OGS, MANCHESTER PROPOSED PLANNING AMENDMENTS - Z2

180146

June 2021 - Revision A

GENERAL ARRANGEMENT
PROPOSED

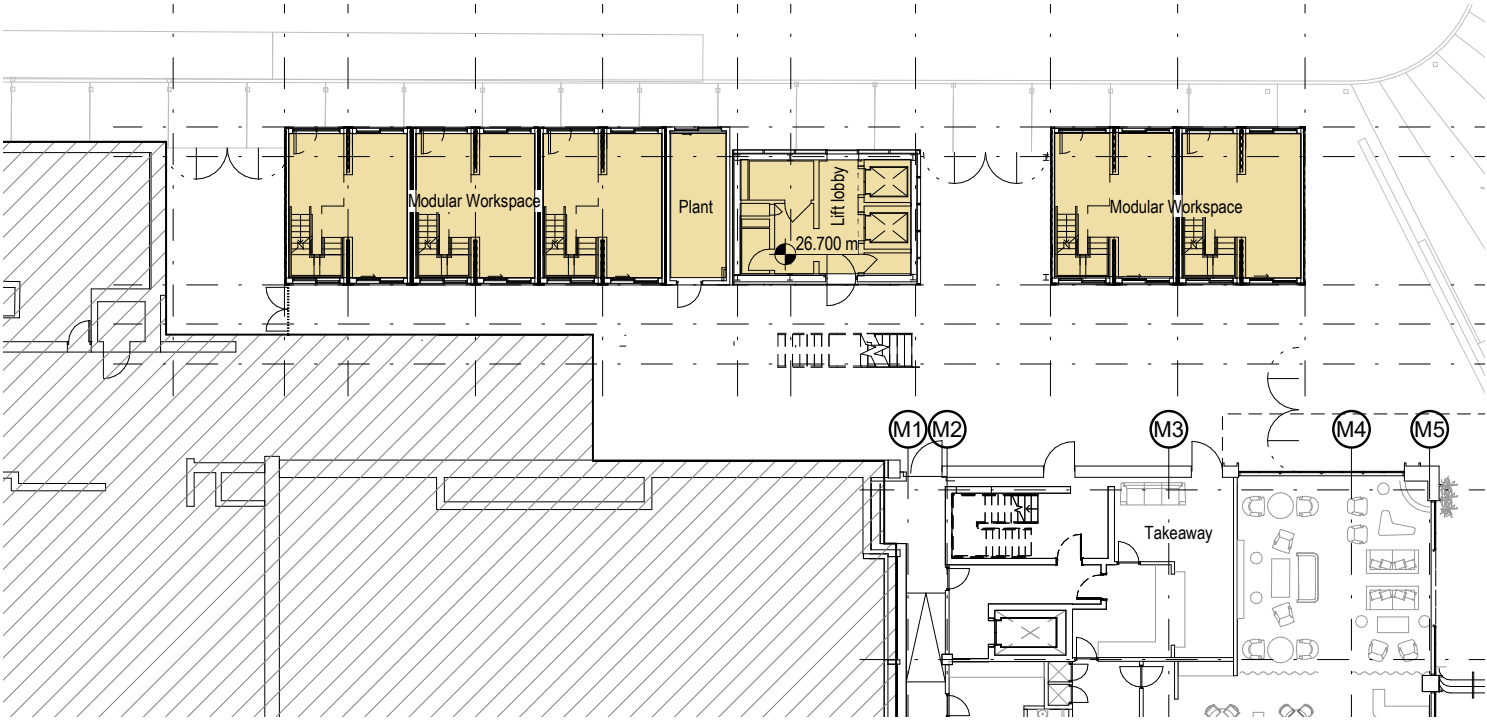
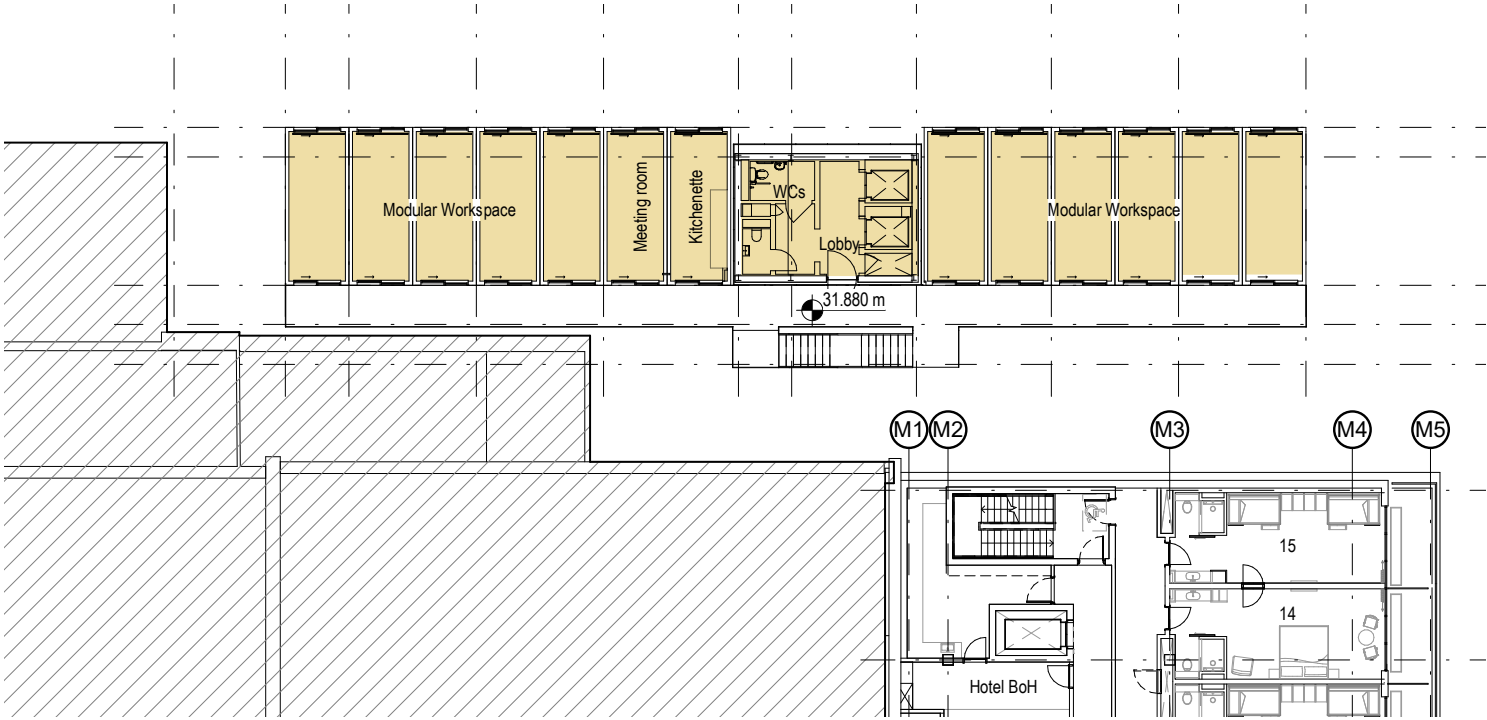
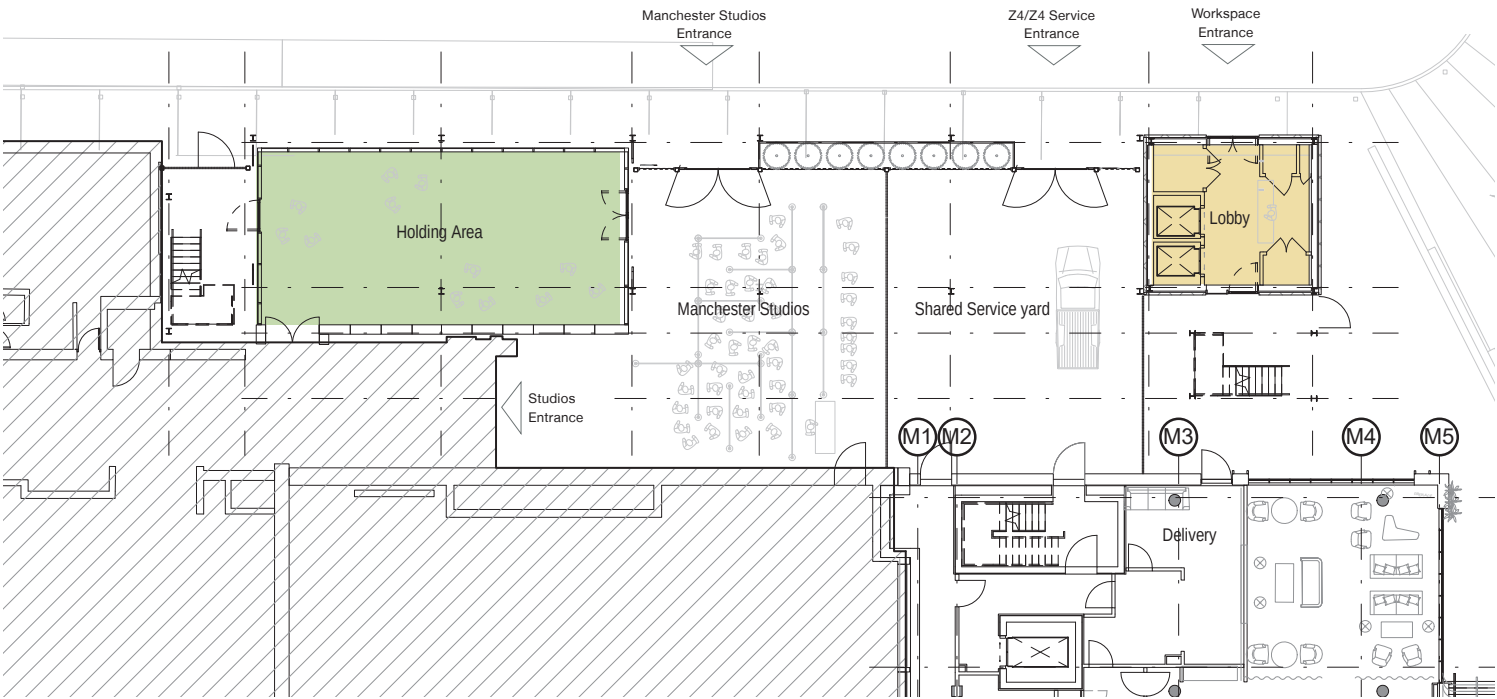
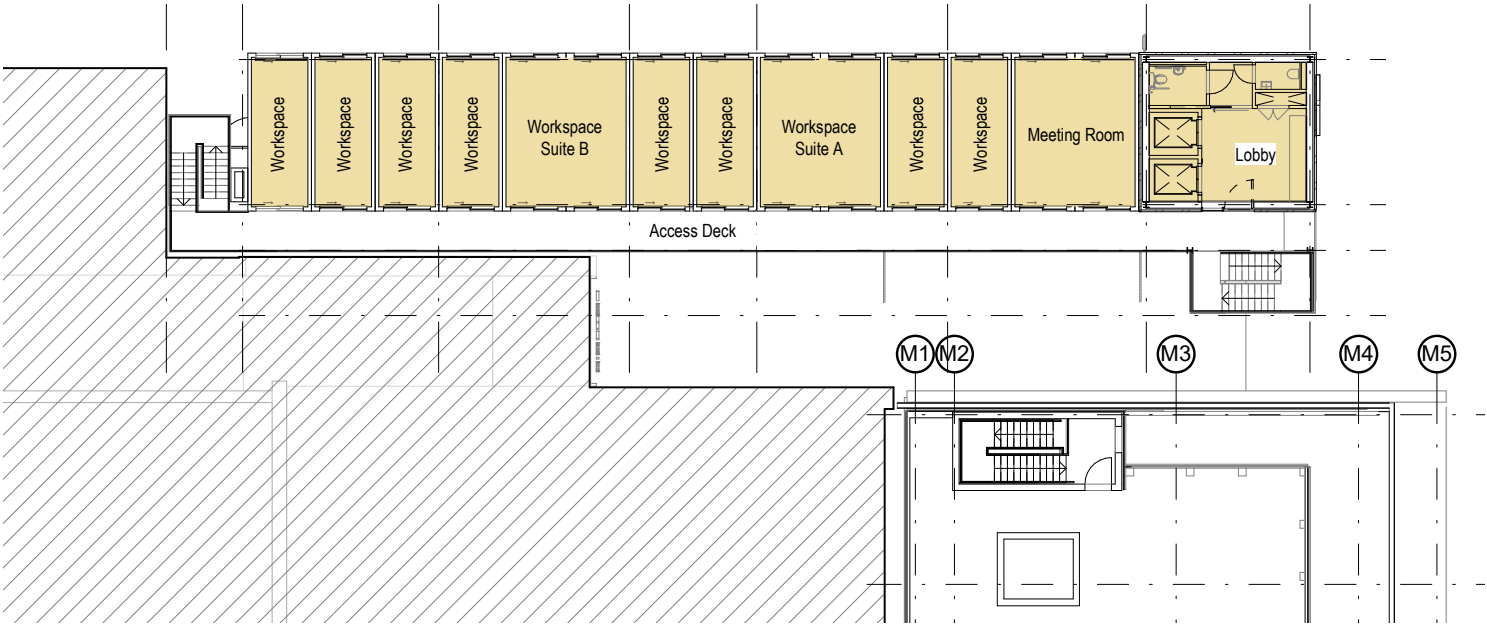
As the studios are being prepared to start recording again in the next couple of months, we are proposing to adapt the ground floor of the container workspace to create a more open & flexible ground floor.

- Removing container workspace from the ground floor to create an internal pre-function space for the studios.
- The workspace and studios have been liaising to ensure that the holding area can also be used to manage the dispersal of crowds after evening events to minimise disruption to local residents.
- Creation an off road delivery area to service Mollies Hotel and the studios.
- The configuration and adaptability of the containers has evolved to satisfy the tenant requirements.
